UNITED STATES PATENT AND TRADEMARK OFFICE

Office Action Summary	Application No. 10/511,650	Applicant(s) BJERKEMO, JAKOB	
	Examiner Stephen A. Holzen	Art Unit 3644

DETAILED ACTION

The examiner has printed images of the MiG-35 (MiG-1.44) from various on-line sources to illustrate the aircraft.

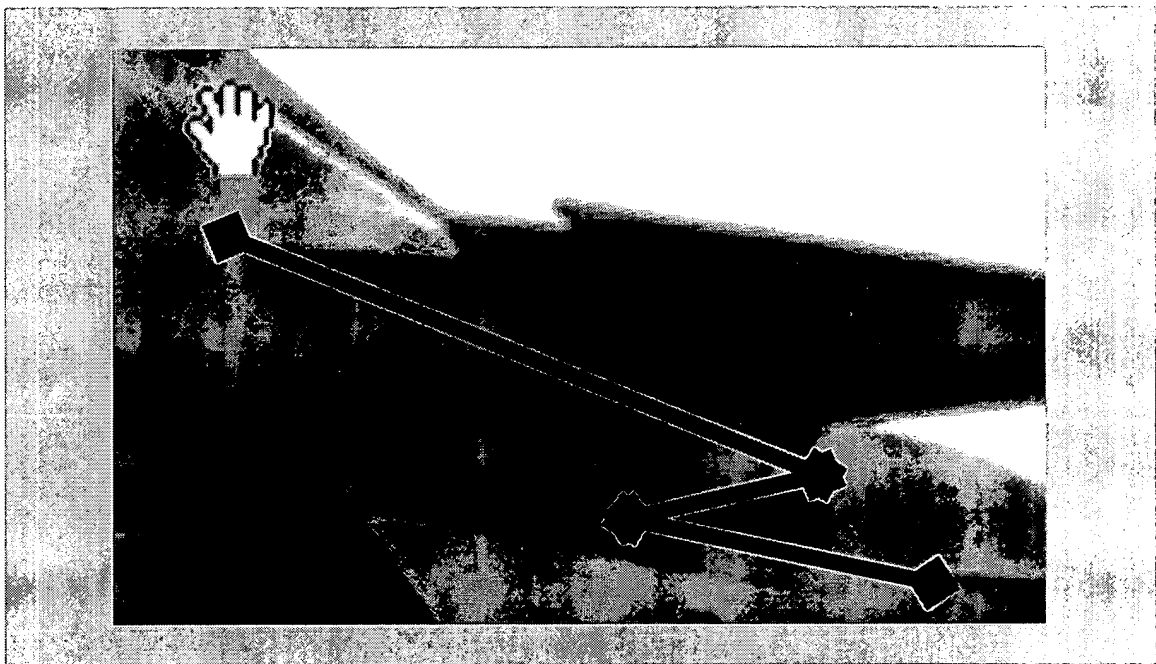
It can be seen from the photograph above that the MiG-35 (MiG 1.44) has a canard and a wing on different planes, there is a fold on the exterior of the craft that runs between the canard and the wing. It should be appreciated that the photo above (and those attached) teaches every limitation of applicant's claims. The examiner does not believe it is necessary to outline the rejection of these claims because the photograph above provides the best explanation of how the prior art reads on the claims. Additionally the examiner asserts that the photograph above and those attached are substantially similar to applicant's own drawings (see Figure 2 of the presently filed application).
